Access Compliance Report

Public Rights-of-Way

(Curb Ramps)

Intersection ID: 5833	Main Street: GUM_BRANCH_RD	Cross Street: KENTBERRY_DR	Location: S
ADA ID: 34CEB7DE5573	Ramp Type: Directional1	Initial Pass/Fail: Pass	Overall Compliance: No
			Severity Score: 15

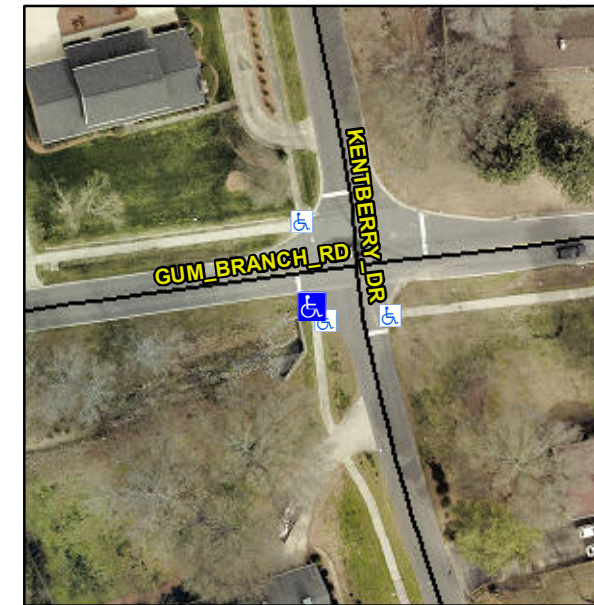
**R304.5.3, R305.1.4, R305.2, R302.7,
R302.7.2, R304.5.4**

Compliance	Description	Data	Compliance	Description	Data
N/A	Ramp Length (in)	87.0	Yes	Grade Break?	Yes
Yes	Ramp Width (in)	58.0	Yes	Grade Break Slope (%)	2.1
Yes	Ramp Slope (%)	0.6	No	Grade Break XSlope (%)	3.1
Yes	Ramp XSlope (%)	1.9			
N/A	Flare Type LT	N/A	N/A	Flare Type RT	N/A
N/A	Flare Slope LT (%)	N/A	N/A	Flare Slope RT (%)	N/A
N/A	Flare Traversable LT?	N/A	N/A	Flare Traversable RT?	N/A
Yes	Landing Length (in)	58.0	Yes	DWS Provided?	Yes
Yes	Landing Width (in)	58.5	Yes	DWS Contrast?	Yes
Yes	Landing Slope (%)	0.3	Yes	DWS Length (in)	24.5
Yes	Landing X Slope (%)	1.2	No	DWS Full Width?	No
N/A	Landing Curb? (Y/N)	No	No	DWS Offset LT (in)	5.0
N/A	Shared Landing?	Yes	Yes	DWS Offset RT (in)	36.0
No	Gutter Ponding?	Yes	No	Gutter Slope (%)	8.6
No	Gutter Lip Ht (in)	0.5	Yes	Gutter X Slope (%)	0.3
N/A	Painted X Walk1?	No		Road Slope (%)	0.9
	X Walk 1 Direction	To N		Road X Slope (%)	0.2
	X Walk 1 Width (in)	N/A		Clear Space?	Yes

**Remove & Replace Entire Ramp.
Remove & Replace Gutter.**
